# Access Compliance Report

## Public Rights-of-Way

### (Curb Ramps)

Intersection ID: 10581	Main Street: ANDERSON_ST	Cross Street: MEADOW_LN	Location: NE
ADA ID: 83C4DA03C93F	Ramp Type: PerpDiag	Initial Pass/Fail: Fail	Overall Compliance: No
		Severity Score: 25

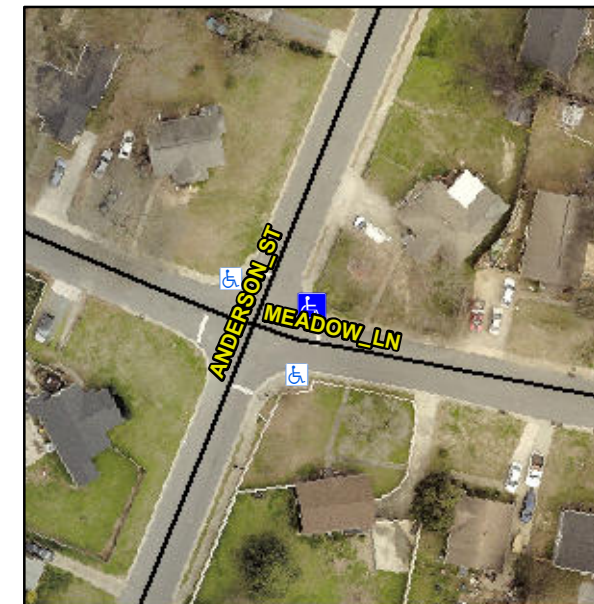
**R304.2.2, R304.5.3**

Compliance	Description	Data	Compliance	Description	Data
N/A	Ramp Length (in)	56.5	No	Ramp Slope (%)	11.9
Yes	Ramp Width (in)	48.0	No	Ramp XSlope (%)	5.8
N/A	Flare Type LT	N/A	N/A	Flare Type RT	N/A
N/A	Flare Slope LT (%)	N/A	N/A	Flare Slope RT (%)	N/A
N/A	Flare Traversable LT?	N/A	N/A	Flare Traversable RT?	N/A
N/A	Landing Length (in)	N/A	N/A	DWS Provided?	N/A
N/A	Landing Width (in)	N/A	N/A	DWS Contrast?	N/A
N/A	Landing Slope (%)	N/A	N/A	DWS Length (in)	N/A
N/A	Landing X Slope (%)	N/A	N/A	DWS Full Width?	N/A
N/A	Landing Curb? (Y/N)	N/A	N/A	DWS Offset (in)	N/A
N/A	Shared Landing?	N/A			
N/A	Gutter Ponding?	Yes	N/A	Gutter Slope (%)	N/A
N/A	Gutter Lip Ht (in)	N/A	N/A	Gutter X Slope (%)	N/A
N/A	Painted X Walk1?	No	N/A	Painted X Walk2?	No
	X Walk 1 Direction	To NW		X Walk 2 Direction	To SW
N/A	X Walk 1 Width (in)	N/A	N/A	X Walk 2 Width (in)	N/A
	X Walk 1 Slope (%)	4.5		X Walk 2 Slope (%)	0.2
	X Walk 1 X Slope (%)	0.2		X Walk 2 X Slope (%)	6.6

**Remove & Replace Curb Ramp With Two New Directional Ramps or Equivalent.**
